Federal Lands Highway Post-Construction Safety Reviews

Final Report

January 2004

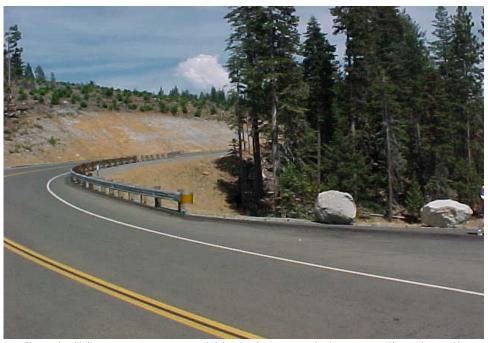
Example of improper signing as the warning sign is above a regulatory sign on the same Post. Also note the pavement drop-off is greater than 2 inches.
